## HIGHLAND COUNCIL

**Report Title:** 22/04580/S37: Scottish Hydro Electric Transmission Plc  
Ardmore Sub-Station, Ardmore, Hallin, Dunvegan

**Description:** Skye Reinforcement Project - Construct and operate approximately 110 kilometres (km) of new double circuit steel structure 132 kV overhead transmission line and associated infrastructure

Title: Figure V2-3.4-S4a  
Section 4 Visual Receptors

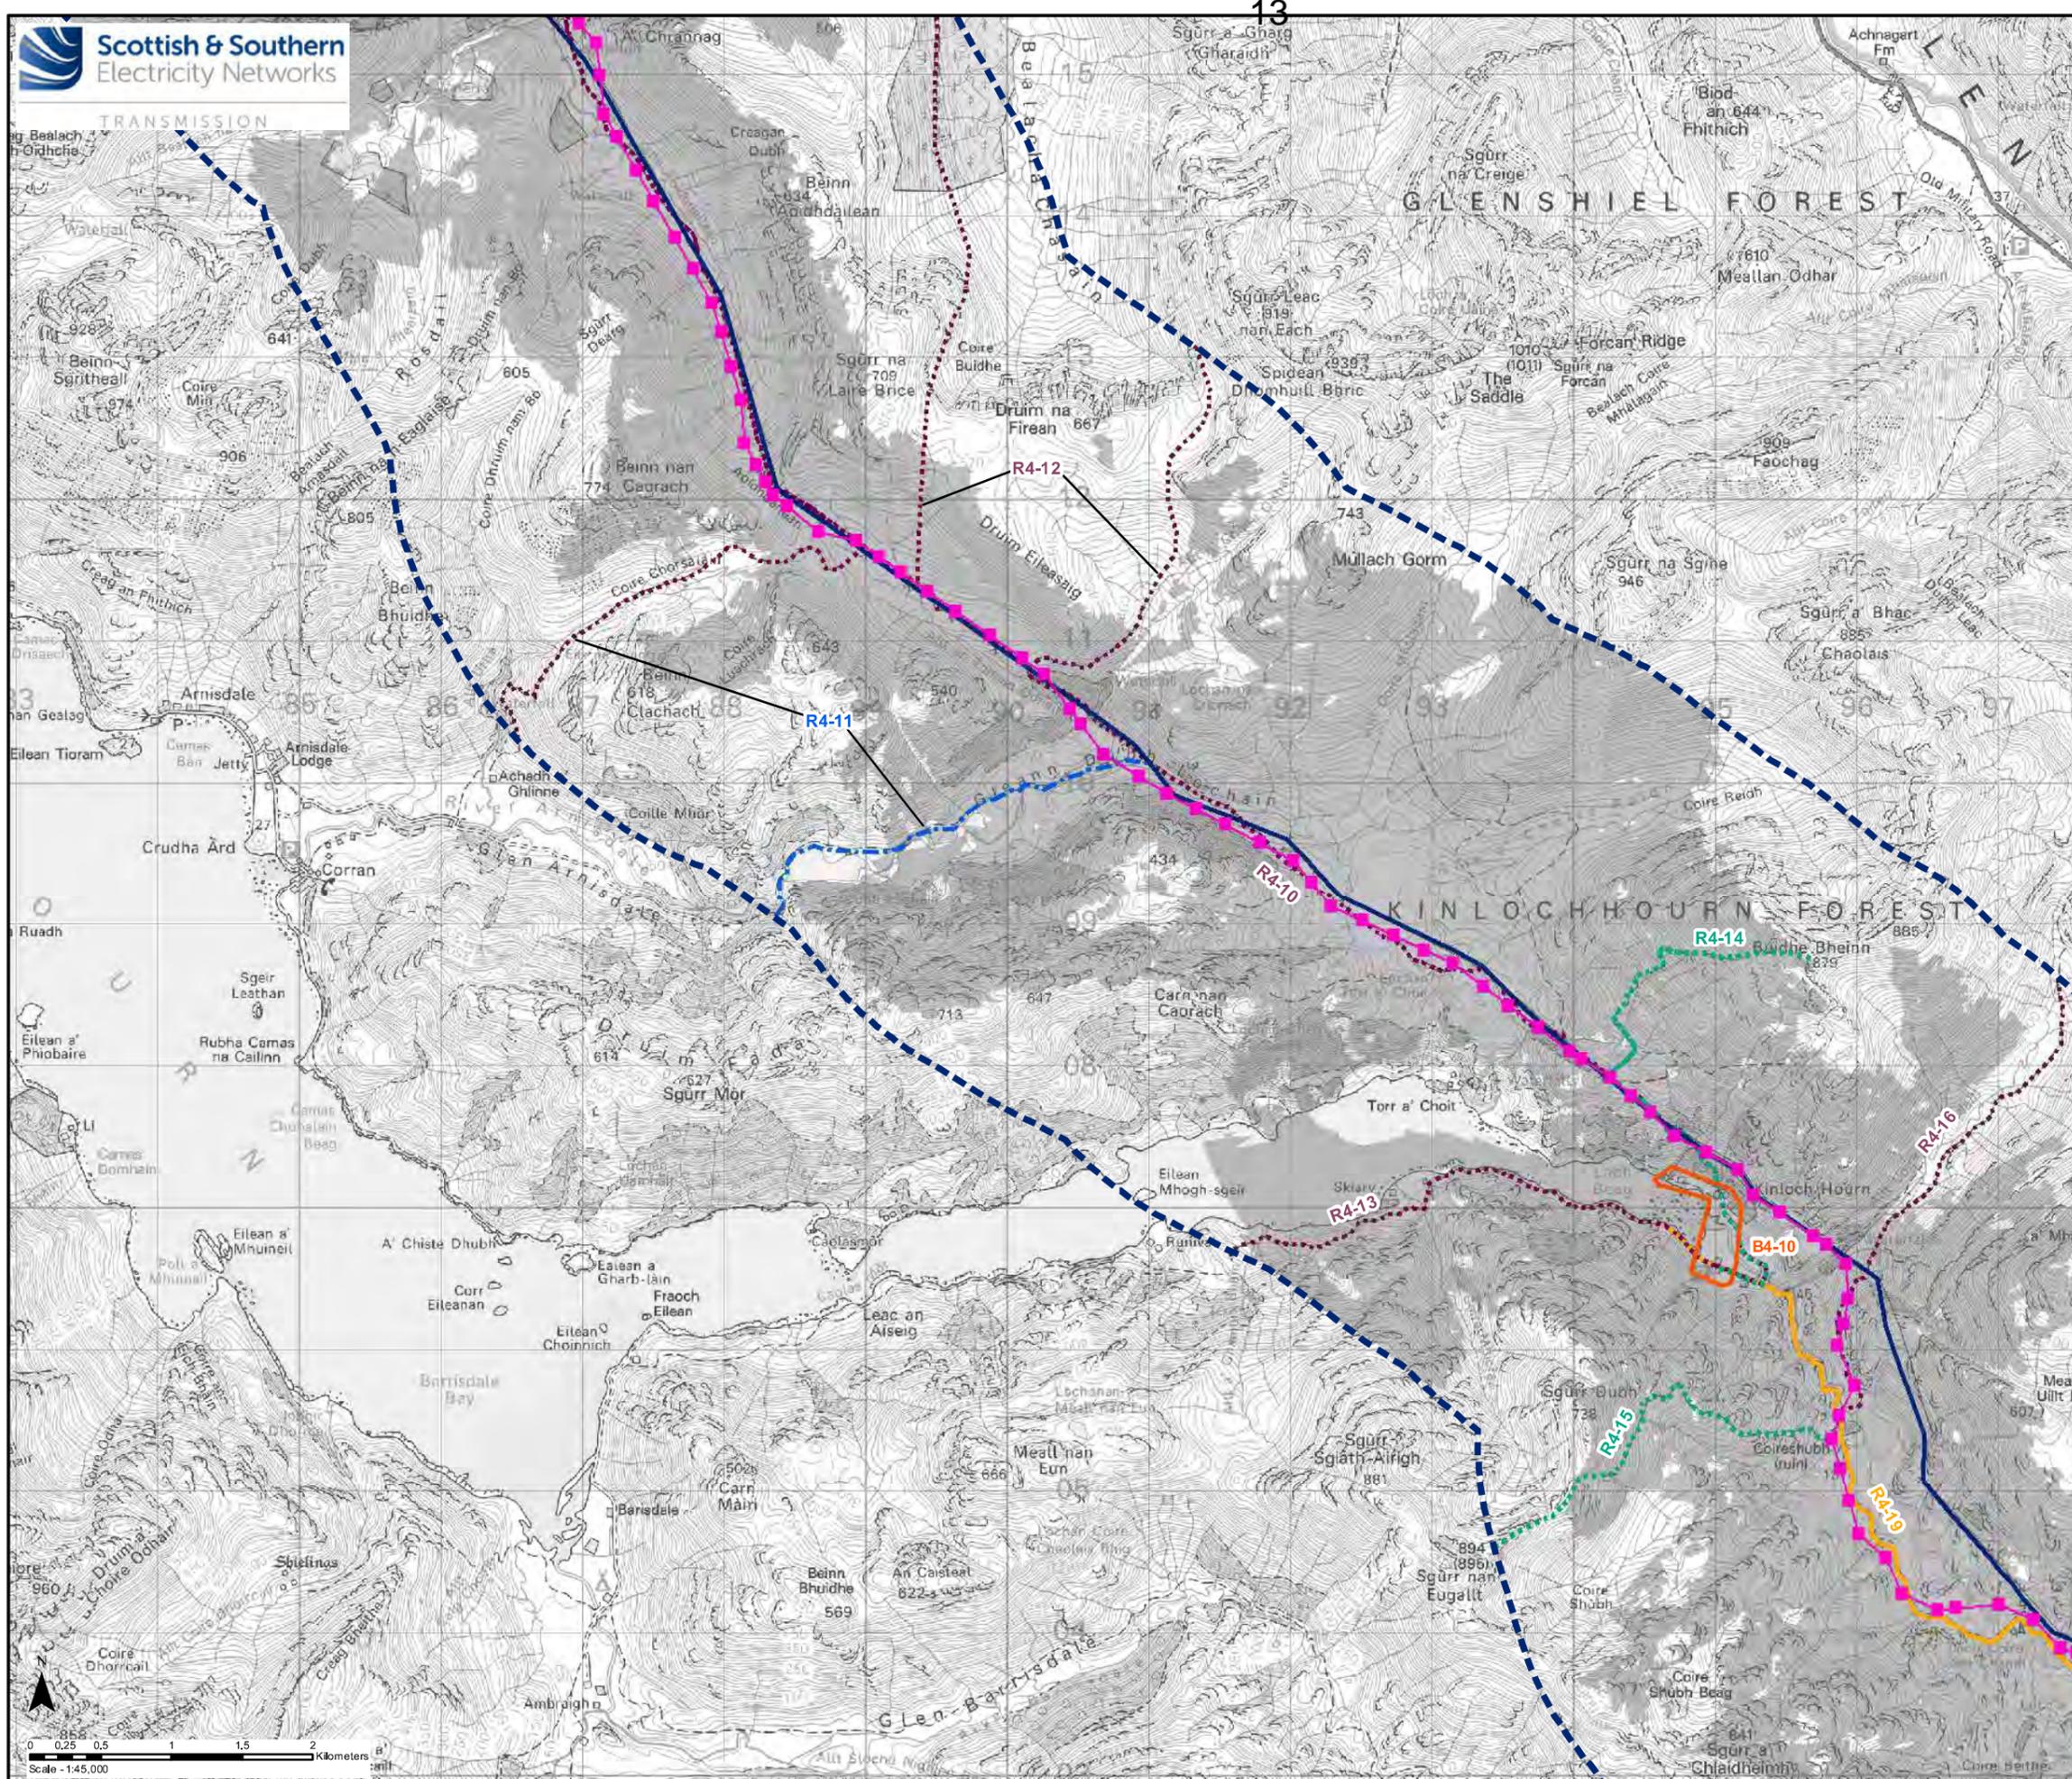
<b>Receptor</b> (Buildings, Routes and Outdoor Locations)	<b>Attributable / Nearby Visual (VL)</b>	<b>Nature of Effect (APP)</b>	<b>Nature of Effect (THC)</b>
		Minor – Moderate Adverse (not significant) (Operational)	
<b>Section 4 – EIA Figure: V2-3.4-S4a, V2-3.4-S4b, and V2-3.4-S4c</b>			
B4-7: Near Balavoulin	VL4-1	Moderate Adverse and Significant (Construction) / Minor / Moderate Adverse (not significant) (Operational)	<b>Moderate Adverse and Significant (Construction and Operational)</b>
R4-9: Track between Balvraid and Srath a' Chomair	-	Moderate Adverse and Significant	Agreed
R4-10: Route between Srath a' Chomair and Kinloch Hourn	VL4-2 VL4-3	Moderate Adverse and Significant	Agreed
R4-14: Buidhe Bheinn Mountain Route	VL4-4	Locally Moderate Adverse and Significant	Agreed
R4-16: Scottish Hill Track 256	-	Locally Moderate Adverse and Significant	Agreed
R4-19: Kinloch Hourn Minor Road	VL4-5	Moderate Adverse and Significant	Agreed

Title: Figure V2-3.4-S5  
Section 5 Visual Receptors

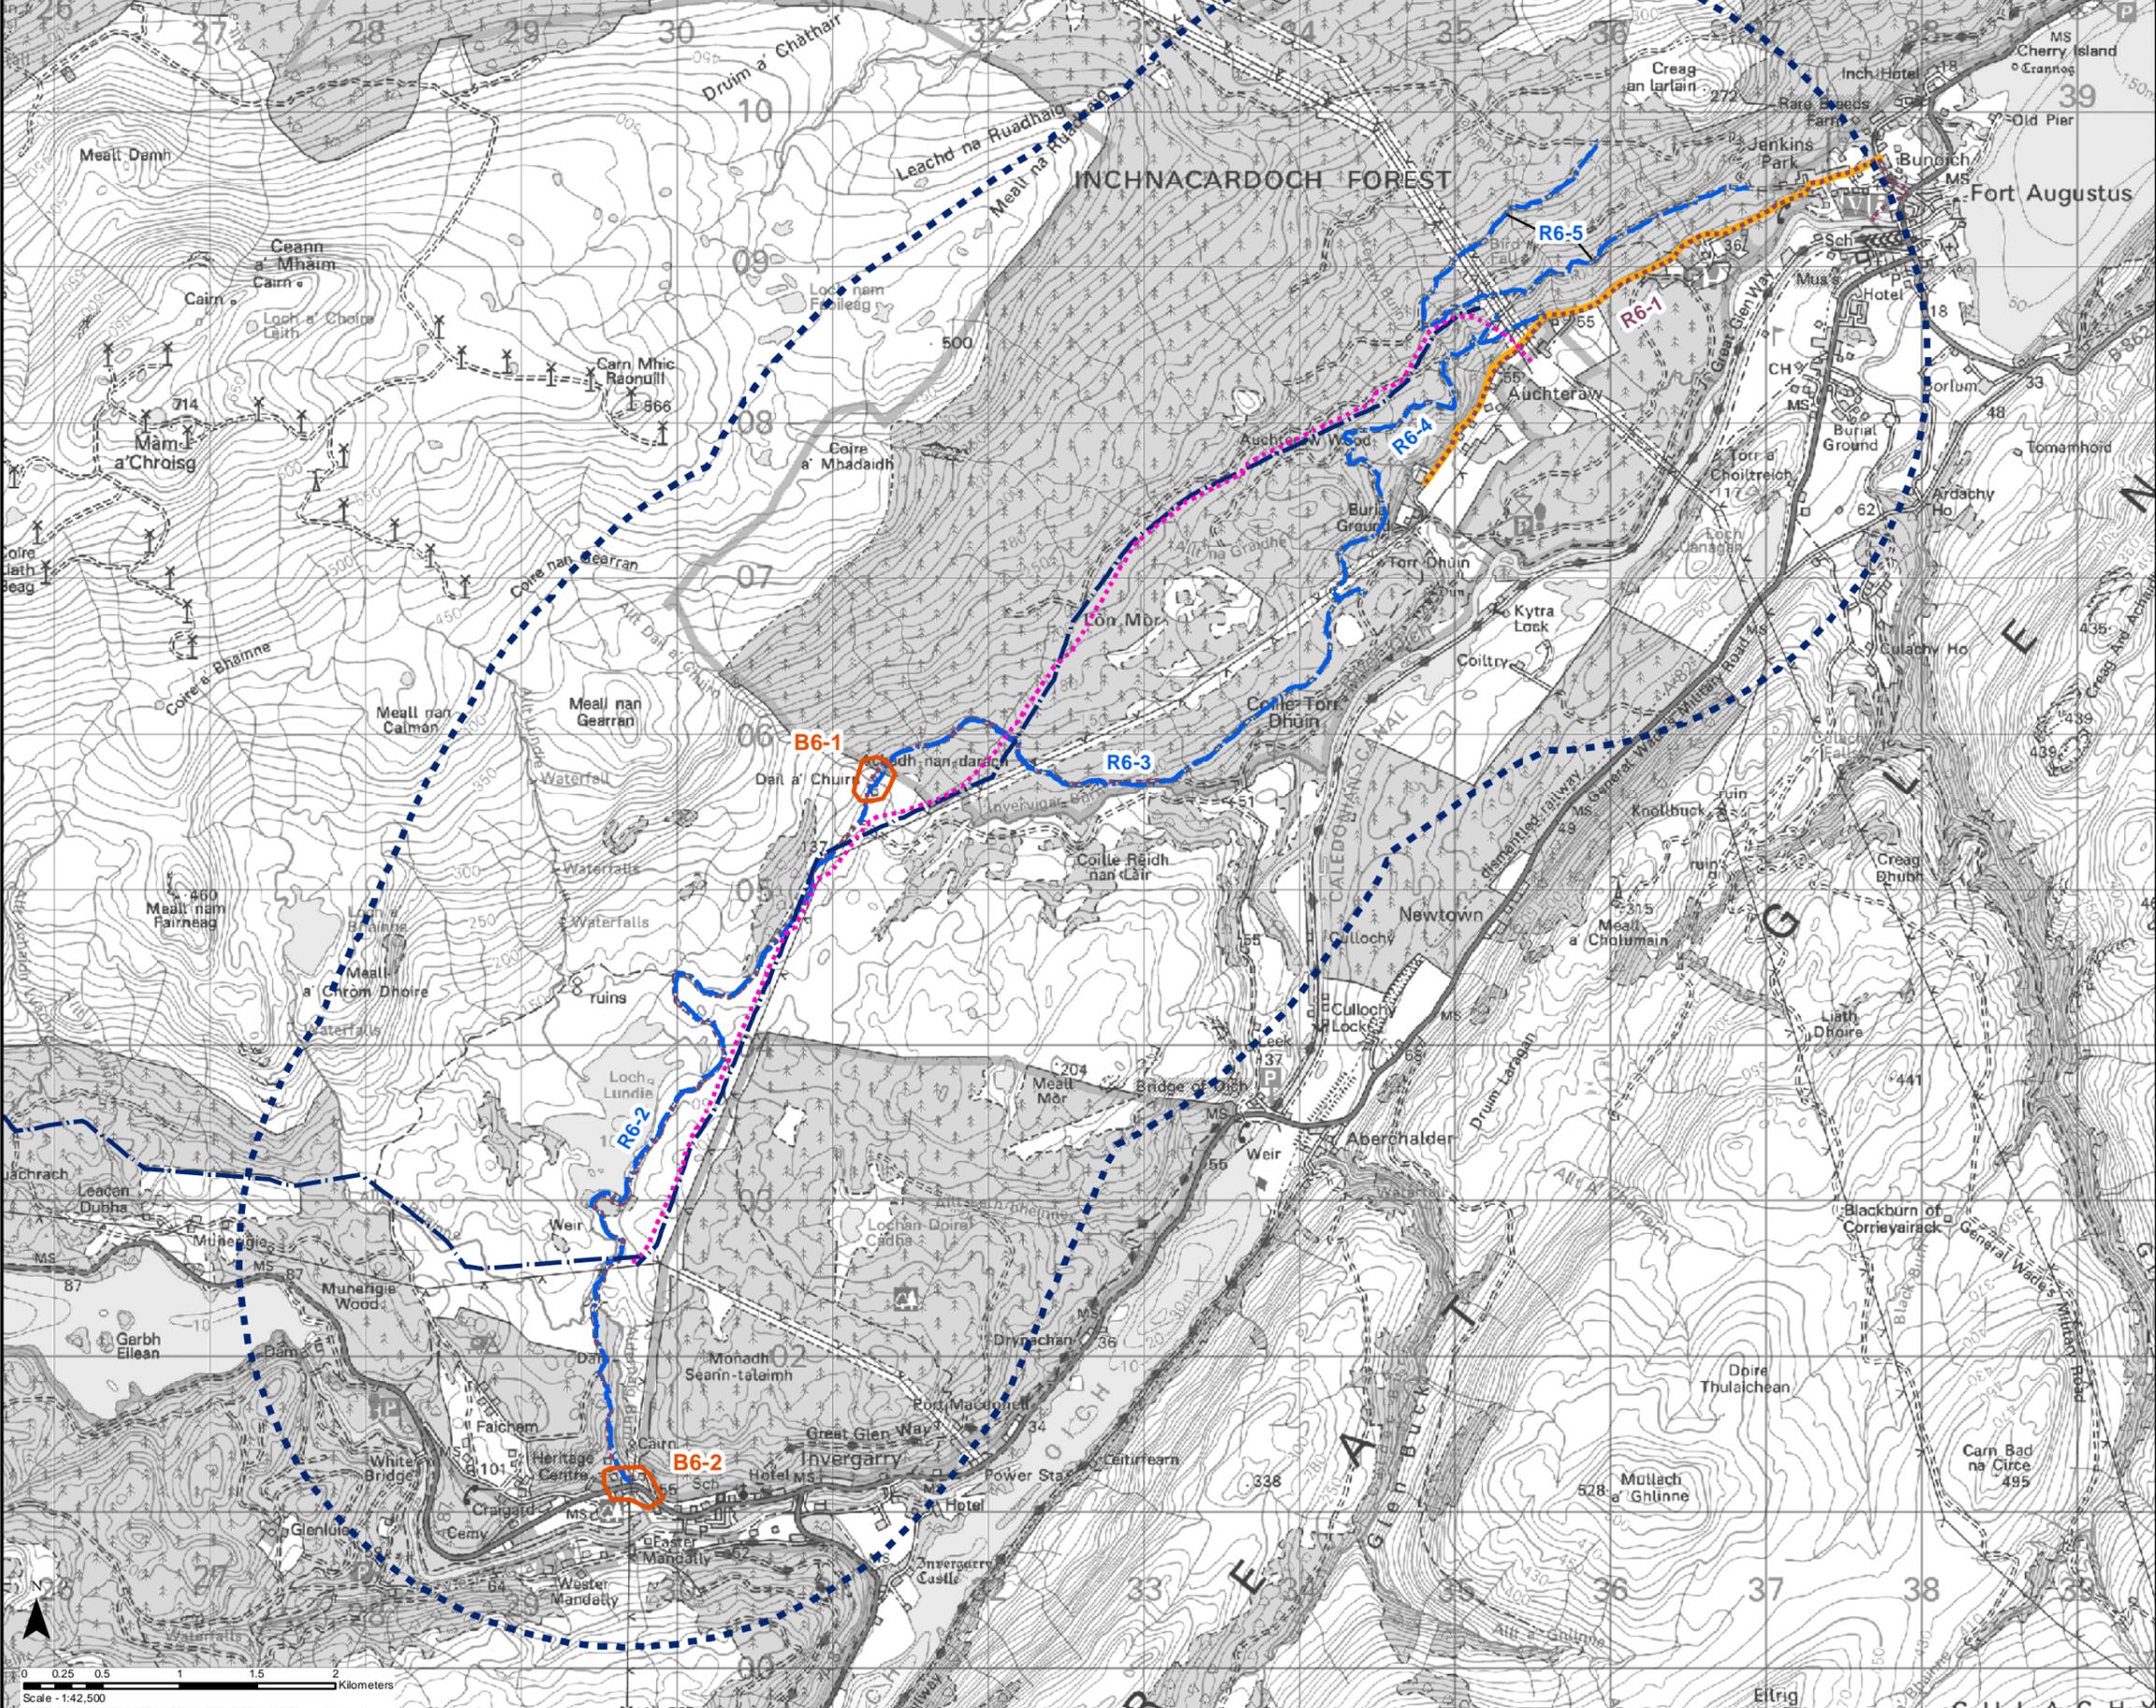
<b>Section 5 - EIA Figure: V2-3.4-S5</b>			
B5-12: Leacan Dubha and Munerigie	-	Major Adverse and Significant (Construction) /	Agreed
